UNITED STATES PATENT AND TRADEMARK OFFICE

APPLICATION NO.	FILING DATE	FIRST NAMED INVENTOR	ATTORNEY DOCKET NO.	CONFIRMATION NO.
10/670,954	09/25/2003	Alois Lustenberger	132702-0128	7063

Office Action Summary

DETAILED ACTION

Fig. 8

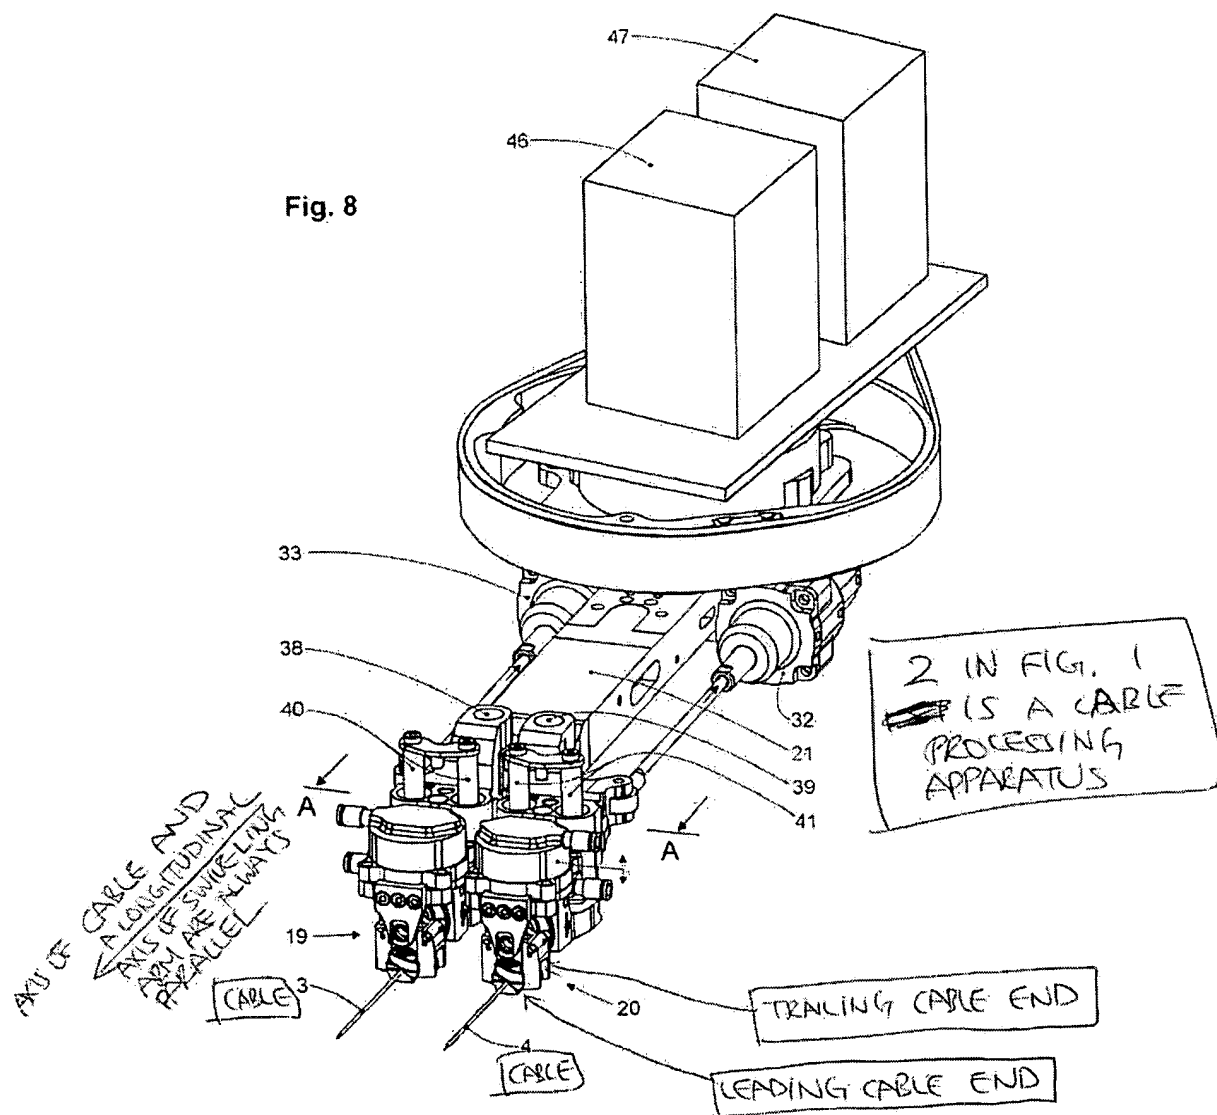
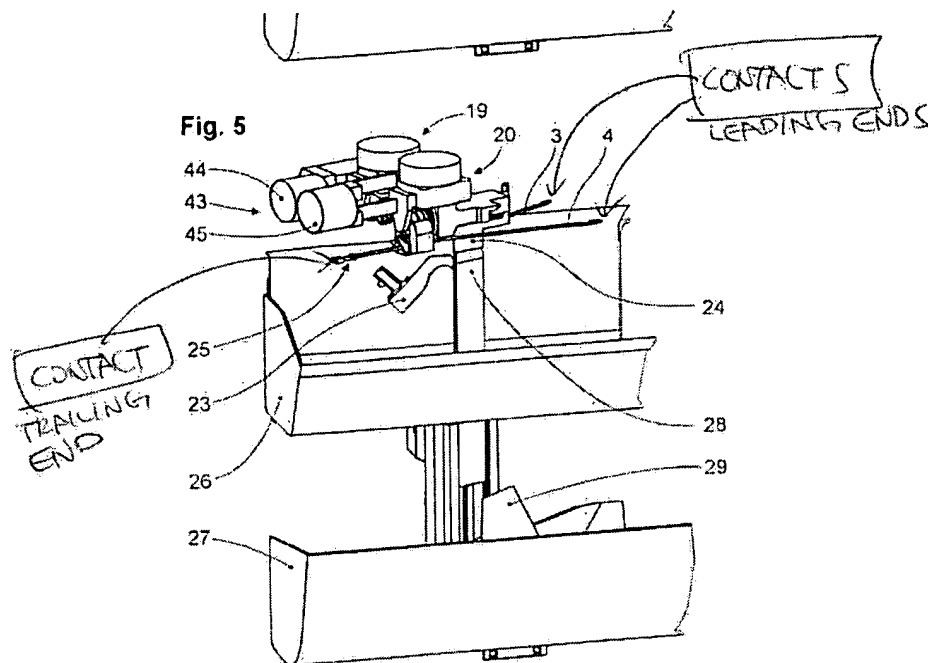
3. Claims 17-32 are rejected under 35 U.S.C. 102(e) as being anticipated by Conte (US 6,658,726).

Conte discloses in Fig. 1 8-11 and 22 of different cable-end processing stations and 22 being a double crimping unit; 5-6 provide cables and belt drives; 7 is the swiveling arm and gripper; Fig. 8 shows a turntable with a belt drive below 46 and 47; 14 is a cable transportation belt.
